# Kirby Morgan Dive Systems, Inc.®

**Bulletin #6 of 2010. October 6, 2010**

**Change To Product Bulletin**

**Length of Part Number 530-024, Screw, Increased**

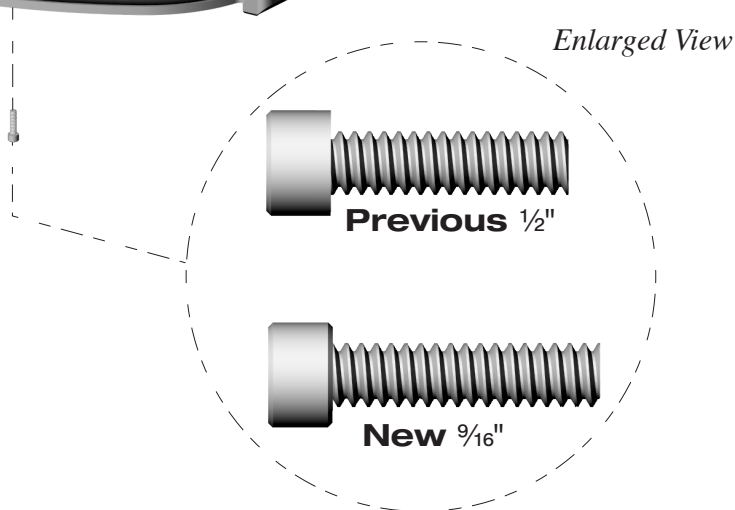
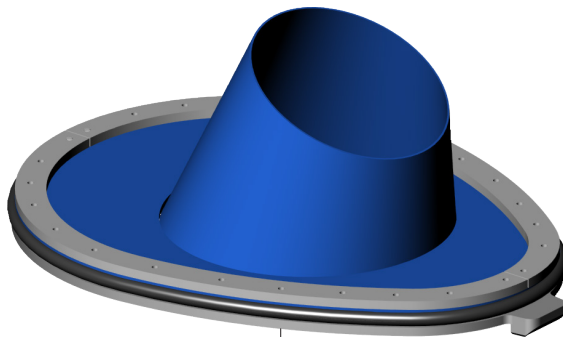
Kirby Morgan has slightly increased the length of part number 530-024, neck ring assembly screw, to better accommodate the various **dry suit yokes** that may have variations in thickness. This will help provide maximum thread engagement when using a lock in dry suit configuration.

The length of the screw was increased from  $\frac{1}{2}$ " to  $\frac{9}{16}$ ". **The length added to the screws was done in case needed. The additional length is not required for standard neck dams.**
